Authorized Field Change

AFC G-04907

Subject: Front Steer Axles, with Code 29WLE, in Certain 4400 Models, Built Between February 3, 2004 and July 27, 2004 Require a Washer Installed Between the Spindle Nut and Bearing

Model: 4400

Figure 1 Front Steer Axle Spindle Assembly

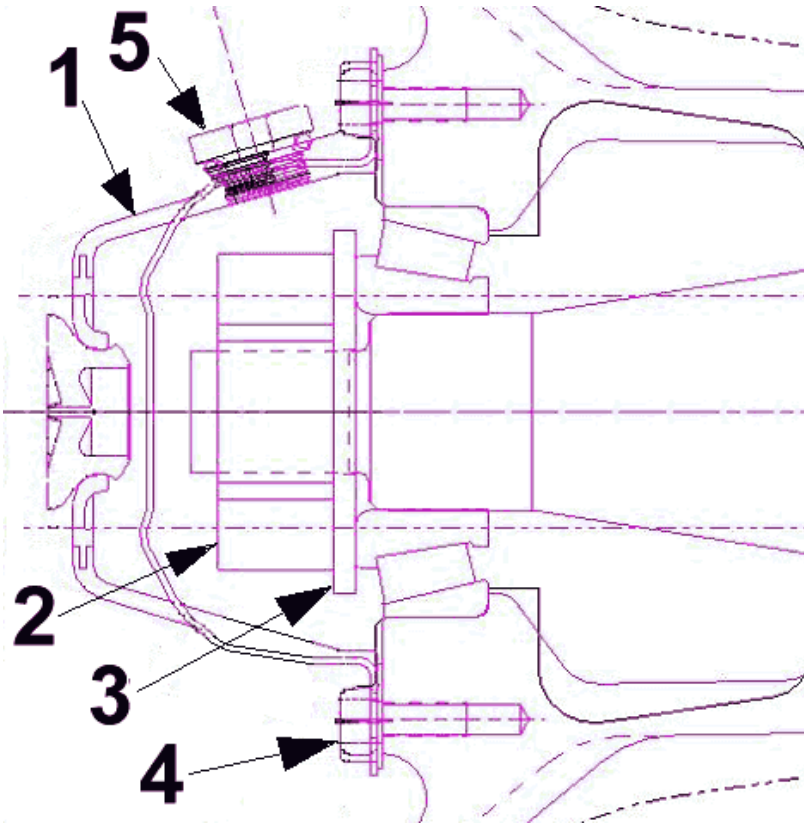
1. Raise the front axle until the tires are no longer in contact with the floor.
2. Remove the fill plug (Figure 1, Item 5), drain the oil, remove the hub cap and gasket (Figure 1, Item 1).

1. Keeper
 2. PRO-TORQ Nut
 3. Pry Here with Small Screwdriver
5. Install washer, Part Number 1663196C1, onto the spindle and against the wheel bearing.
 6. **A.** Reinstall the PRO-TORQ nut and tighten to 180 to 220 Lbf-ft (244 to 298 Nm) while rotating the hub assembly a minimum of one complete revolution.

Figure 2 PRO-TORQ® Spindle Nut Assembly

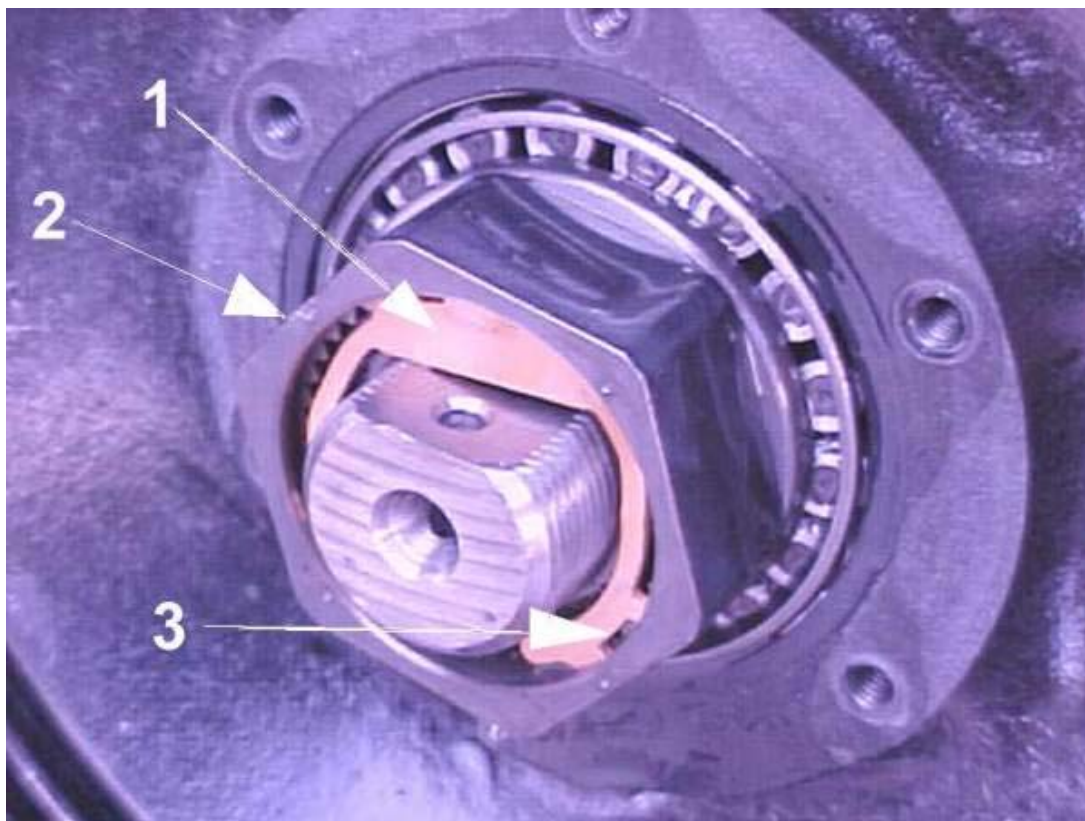
1. Hub Cap
 2. PRO-TORQ® Nut Assembly
 3. Spindle Washer
 4. Hub Cap Mounting Screws (6)
 5. Fill Plug
-
3. Insert a small screwdriver (Figure 2, Item 3) and carefully remove the nut keeper (Figure 2, Item 1) from the internal groove in the nut.
 4. Remove the nut.

B. Back off the nut 1/2 turn and re-tighten to 45 to 55 Lbf-ft (61 to 75 Nm).
C. Back off the nut 1/8 turn to achieve a final end play setting of 0.001 to 0.005 inch. End play must be verified with a magnetic base dial indicator.

7. Reinstall the PRO-TORQ nut keeper making sure it is seated in the internal groove in the nut. If the keeper cannot be fully seated in the groove, do not loosen the nut, but rather tighten the nut a small amount to allow the keeper to be seated.
